**Amendments to the Statewide Urban Design and Specifications (SUDAS)  
Design Standards Manual and Specifications Manual by the City of Tiffin  
Approved Date: January 2019**

The Statewide Urban Design and Specifications (SUDAS) Design Standards Manual shall be adopted with the following amendments:

- 2.) Figures G-1.02 and 2G-1.03 show typical installation details.

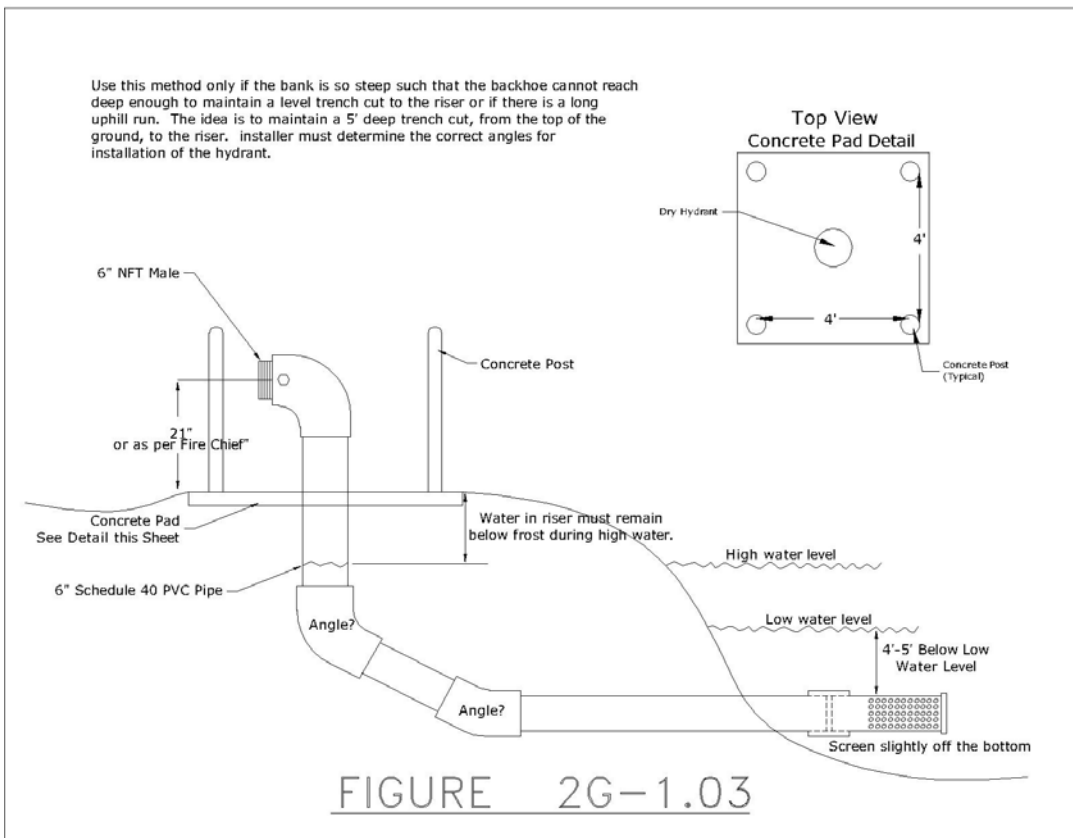
a. Dry Hydrant Installation

- 1.) All wet-bottom detention facilities shall have an emergency vehicle accessible dry hydrant installed. Additional information regarding installation is available at the Office of the City Engineer. All dry hydrants installation sites will be approved by the Fire Chief and construction drawings will be approved by the Fire chief and City Engineer.
